Project **IEEE 802.16 Broadband Wireless Access Working Group** <<http://ieee802.org/16>>

Title **DL HARQ for non-transparent Relays**

Re:	This is in response to the call for proposals 80216j-07_007.pdf
Abstract	This contribution proposes a procedure for handling retransmission of HARQ failure attempts in a relay system.
Purpose	Add proposed spec changes in P802.16j Baseline Document (IEEE 802.16j-06/026)
Notice	This document has been prepared to assist IEEE 802.16. It is offered as a basis for discussion and is not binding on the contributing individual(s) or organization(s). The material in this document is subject to change in form and content after further study. The contributor(s) reserve(s) the right to add, amend or withdraw material contained herein.
Release	The contributor grants a free, irrevocable license to the IEEE to incorporate material contained in this contribution, and any modifications thereof, in the creation of an IEEE Standards publication; to copyright in the IEEE's name any IEEE Standards publication even though it may include portions of this contribution; and at the IEEE's sole discretion to permit others to reproduce in whole or in part the resulting IE

Figure 2. Message Flow for 3-hop DL HARQ (successful case)

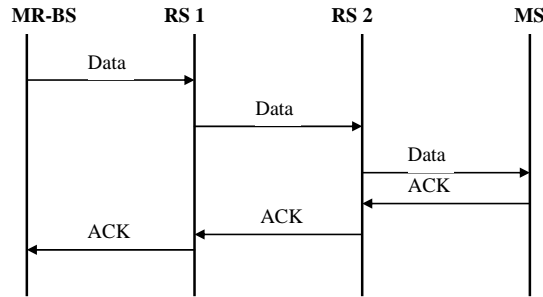
In Figure 2, the data (HARQ sub-burst) is transmitted from the MR-BS to RS 1. If RS 1 receives HARQ sub-burst correctly, it forwards the sub-burst to RS 2 and finally to the MS. As a response to a successful reception of the data at the MS, MS generates ACK. This ACK invokes ACK at RS 2 and RS 1 thereafter, which is relayed to the MR-BS. If RS 2 fails to decode the data, it sends NAK to RS1 and RS1 forwards encoded NAK indicating the failure link to the MR-BS.

Figure 3. Message Flow for 3-hop DL HARQ (HARQ sub-burst is failed on access link)

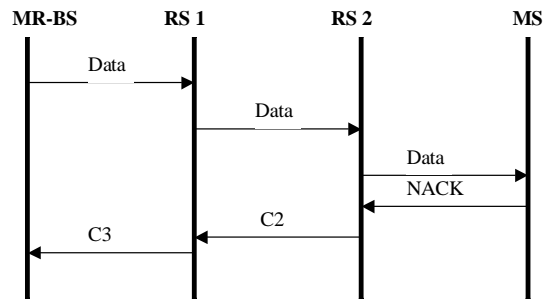
In Figure 3, the data is transmitted from the MR-BS to RS 1 and is forwarded to RS 2 and finally to the MS. If HARQ-burst is failed on access link, MS will send NAK back to RS2. RS2, upon receipt of NAK, sends code C2 back to RS1. RS1, upon receipt of code C2, sends Code C3 (C2+1)\_to the MR-BS. When MR-BS receives code C3, it can determine that the HARQ-burst is failed 3 hop away (i.e. on the access link) and therefore schedule retransmission from RS2.

Figure 4. Message Flow for 3-hop DL HARQ (HARQ sub-burst is failed on relay link)

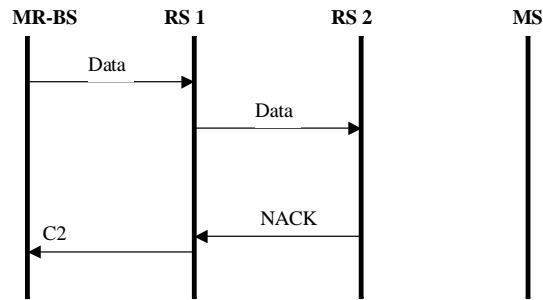
In Figure 4, the data is transmitted from the MR-BS to RS 1 and is forwarded to RS 2. If RS 2 fails to decode the data, it sends NAK to RS1. If RS2 failed to decode HARQ-burst correctly, it does not forward erroneous data to MS. In this case, RS modifies the HARQ-MAP IE such that MS or further downstream RS do not receive the HARQ burst. RS replaces the CID in the HARQ sub-burst IE corresponding to the erroneous packet with its own CID.

When RS1 receives the NAK from RS2, RS1 forwards encoded NAK (C2) indicating the failure link to the MR-BS. When MR-BS receives code C2 for the data, it can determine that the HARQ-burst is failed 2 hop away (i.e. RS1-RS2 link) and therefore schedule retransmission from RS1.
